STAFF REPORT

COMMUNITY DEVELOPMENT DEPARTMENT

SUBJECT: H-2021-0006
Sadie Creek Drive-Through – CUP

A. Proposed Site Plan (dated: 1/27/2021)

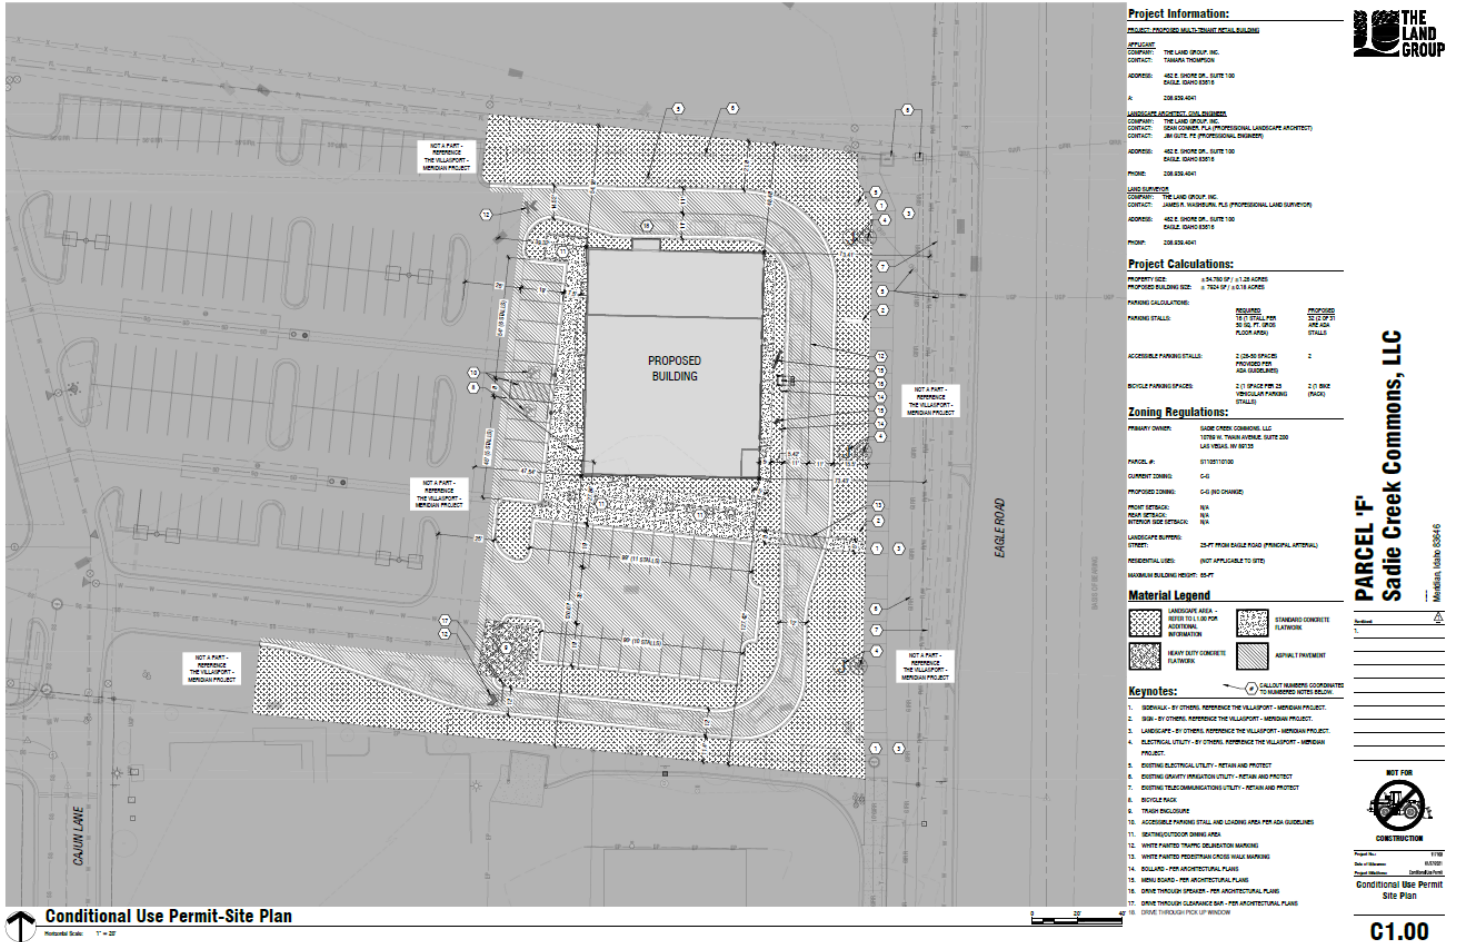
Access: Access is provided to this site from the west via N. Cajun Ln. and E. Picard Ln., both private streets, across the Villasport property to the west and via E. Ustick Rd., an arterial street, from the north. **A cross-access/ingress-egress easement is needed across the adjacent properties to the west and north (Parcels #S1105110111 and S1105110030) for access to this site. A copy of the recorded easements should be submitted with the Certificate of Zoning Compliance application for this project. Both access driveways should be constructed with development of this site along with all of the frontage improvements along E. Ustick Rd. and N. Eagle Rd./SH-55 in accord with the Development Agreement. All off-site driveways and site improvements should be depicted on the plans.**

A pedestrian walkway is depicted on the site plan from the perimeter sidewalk along N. Eagle Rd. to the main building entrance as required by UDC 11-3A-19B.4a. **Where pedestrian walkways cross vehicular driving surfaces, the walkways are required to be distinguished from the vehicular driving surfaces through the use of pavers, colored or scored concrete, or bricks as set forth in UDC 11-3A-19B.4. The site plan submitted with the Certificate of Zoning Compliance application should reflect compliance with this standard.**

2. The site plan and landscape plan submitted with the Certificate of Zoning Compliance application shall be revised as follows:
 - a. The stacking lane, menu and speaker location(s), and window location shall be depicted in accord with UDC [11-4-3-11B](#).

- b. Where pedestrian walkways cross vehicular driving surfaces, the walkways shall be distinguished from the vehicular driving surfaces through the use of pavers, colored or scored concrete, or bricks as set forth in UDC [11-3A-19B.4](#).

- h. Depict both access driveways to this site via E. Ustick Rd. and E. Picard Ln./N. Cajun Ln.
3. Direct access via N. Eagle Rd./SH-55 is prohibited.
4. A recorded cross-access/ingress-egress easement shall be obtained across the adjacent properties to the west and north (Parcel #S1105110111 and #S1105110030) for access to this site; a copy of the easements shall be submitted to the Planning Division with the Certificate of Zoning Compliance application.

C. Conceptual Building Elevations & Perspectives (dated: 1/19/21 & 2/11/21) & Floor Plan (dated: 1/19/21) **NOT APPROVED**

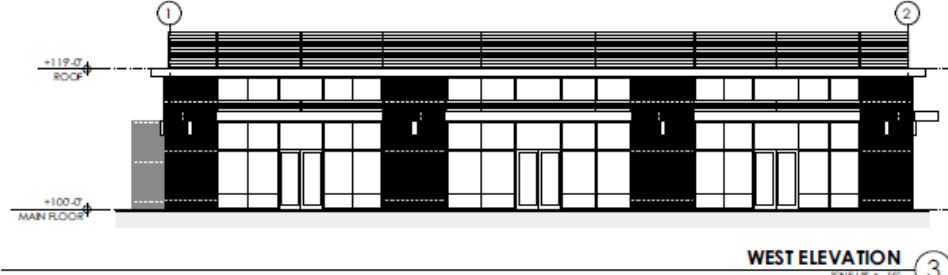
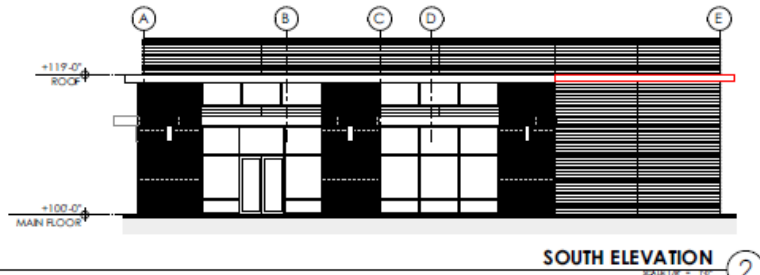
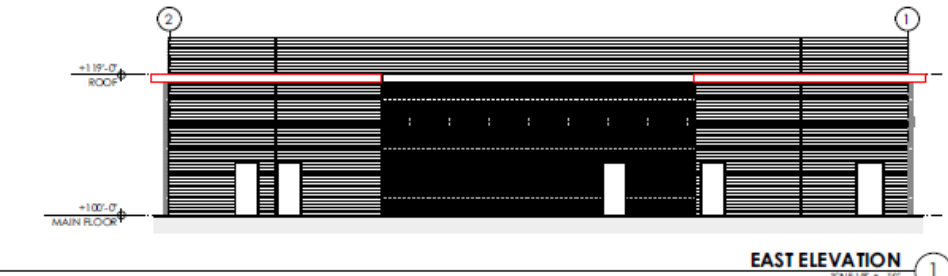
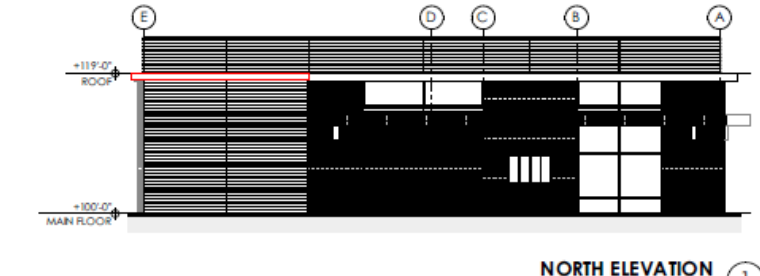
Mechanical Equipment: All mechanical equipment on the back of the building and outdoor service and equipment should be incorporated into the overall design of buildings and landscaping so that the visual and acoustic impacts of these functions are fully contained and out of view from adjacent properties and public streets as set forth in UDC [11-3A-12](#).

Building Elevations: Conceptual building elevations were submitted as shown in Section VII.C that incorporate a mix of materials consisting of PAC clad formed metal wall panels in slate gray with metal flashing and trim in light gray, a mix of white and onyx colored brick and with a glass store-front and a flat roof. **These elevations are *not* approved; final design shall be consistent with the design standards listed in the [Architectural Standards Manual](#).**

The trash enclosure should be constructed with similar materials and colors to match the building.
